STAFF REPORT

SUBJECT: H-2021-0020

Gem Prep South - CUP

A. Proposed Site Plan (dated: 3/29/2021)

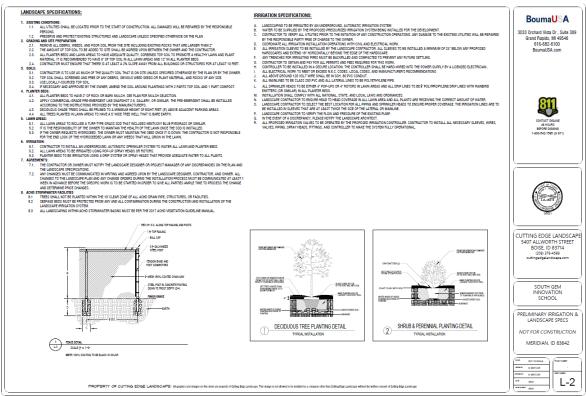
The 5-foot wide sidewalks proposed adjacent to parking should either be widened two feet (2') to seven feet (7') to allow for vehicle overhang (the length of the stall may be decreased 2' in this instance) or wheel stops should be provided in the adjacent parking stalls to prevent vehicle overhang in accord with UDC 11-3C-5B.

Landscaping: Parking lot landscaping is required to be provided in accord with the standards listed in UDC 11-3B-8C. Landscaping is depicted on the landscape plan in Section VII.B in planter islands within the parking area as required; a tree should be added at the east end of the row of parking on the north side of the building where none is proposed.

Landscaping is required along the multi-use pathway along E. Lake Hazel Rd. per the standards listed in UDC 11-3B-12C and should be depicted on the landscape plan.

Fencing: All fencing is required to comply with the standards listed in UDC 11-3A-7. Chainlink fencing is depicted on the landscape plan around the play area adjacent to S. Vertex Way. Because this site is located adjacent to a collector street, Staff recommends a fencing material of higher quality such as wrought iron is provided.

- 2. The site/landscape plan submitted with the Certificate of Zoning Compliance application shall be revised as follows:
 - a. Add a tree at the east end of the row of parking on the north side of the building in accord with UDC 11-3B-8C.2d.

- c. Depict landscaping adjacent to the multi-use pathway along E. Lake Hazel Rd. per the standards listed in UDC 11-3B-12C.
 - d. The 5-foot wide sidewalks proposed adjacent to parking shall either be widened two feet (2') to seven feet (7') to allow for vehicle overhang (the length of the stall may be decreased 2' in this instance) or wheel stops should be provided in the adjacent parking stalls to prevent vehicle overhang in accord with UDC 11-3C-5B.

- e. Change the fencing type around the play area adjacent to S. Vertex Way from chainlink to wrought iron.
 - f. Depict all cross-walks to the school site as included in the school site checklist.
